PLANT SYSTEMS

Mr. Harold R. Denton
Technical Specification 3.7.6
Change Request
August 26, 1983

ATTACHMENT II

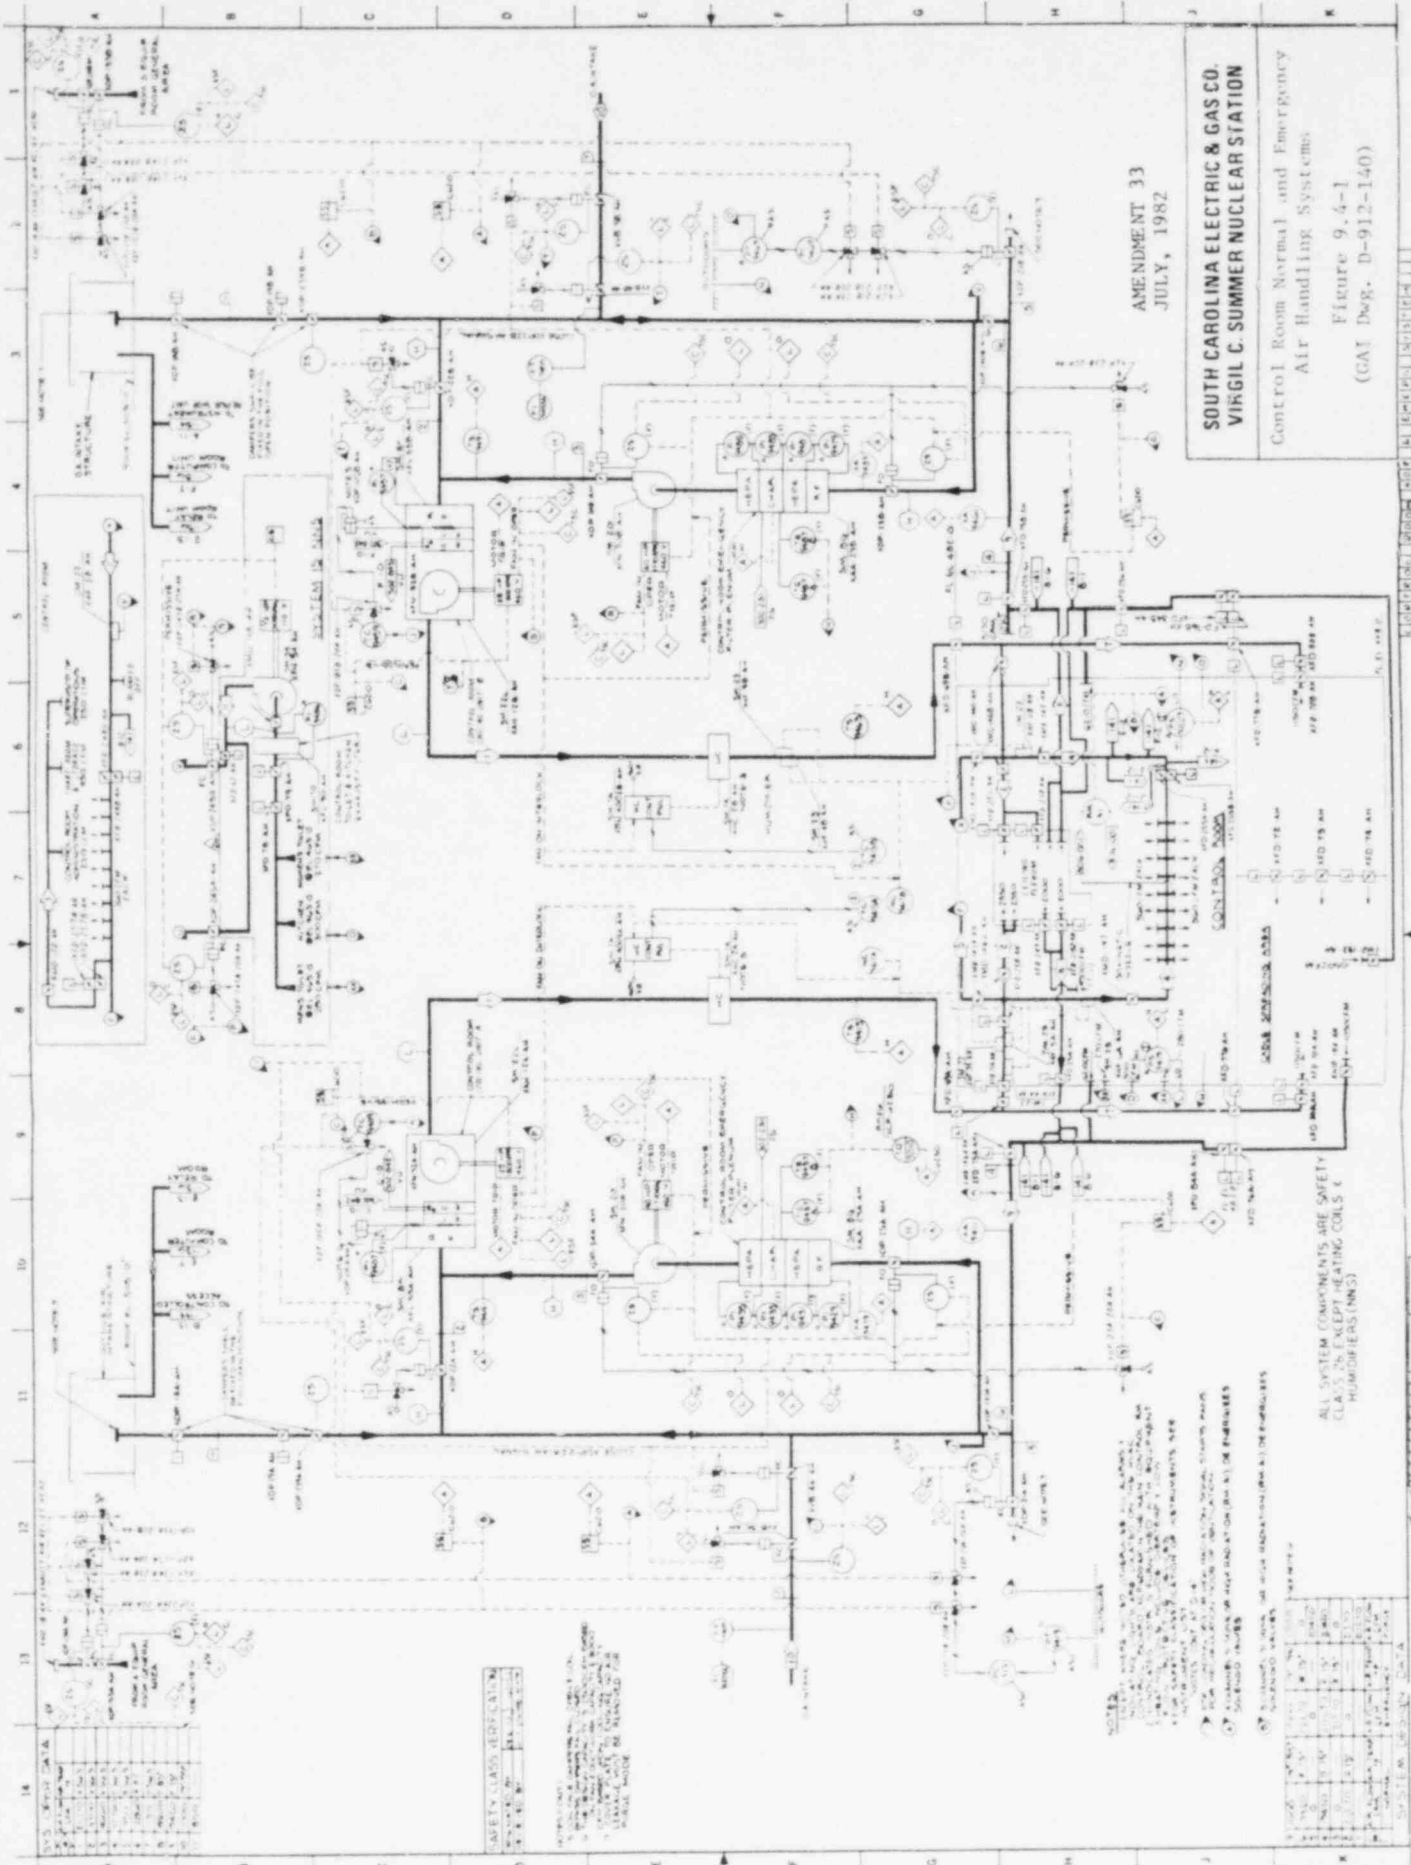
1. Verifying that the cleanup system satisfies the in-place testing acceptance criteria and uses the test procedures of Regulatory Positions C.5.a, C.5.c and C.5.d of Regulatory Guide 1.52, Revision 2, March 1978, and the system flow rate is ~~20,000~~ ^{21,270} cfm \pm 10%.

3. Verifying a system flow rate of ~~20,000~~ ^{21,270} cfm \pm 10% during system operation when tested in accordance with ANSI N510-1975.
- d. After every 720 hours of charcoal adsorber operation by verifying within 31 days after removal, that a laboratory analysis of a representative carbon sample obtained in accordance with Regulatory Position C.6.b of Regulatory Guide 1.52, Revision 2, March 1978, meets the laboratory testing criteria of Regulatory Position C.6.a of Regulatory Guide 1.52, Revision 2, March 1978.

- e. At least once per 18 months by:
1. Verifying that the pressure drop across the combined HEPA and roughing filters and charcoal adsorber banks is less than 6 inches Water Gauge while operating the system at a flow rate of ~~20,000~~ ^{21,270} cfm \pm 10%.

- f. After each complete or partial replacement of a HEPA filter bank by verifying that the HEPA filter banks remove greater than or equal to 99.95% of the DOP when they are tested in-place in accordance with ANSI N510-1975 while operating the system at a flow rate of ~~20,000~~ ^{21,270} cfm \pm 10%.

- g. After each complete or partial replacement of a charcoal adsorber bank by verifying that the charcoal adsorbers remove greater than or equal to 99.95% of a halogenated hydrocarbon refrigerant test gas when they are tested in-place in accordance with ANSI N510-1975 while operating the system at a flow rate of ~~20,000~~ ^{21,270} cfm \pm 10%.

ANSWER: No. The proposed amendment will make the Technical Specifications agree with the existing design and analysis of the Control Room Air Handling System per Amendment 33 in the Final Safety Analysis Report.

ANSWER: No. The proposed amendment will update Technical Specification surveillances to reflect existing system flow characteristics per Amendment 33 of the Final Safety Analysis Report. Therefore, there will be no impact on the margin of safety.
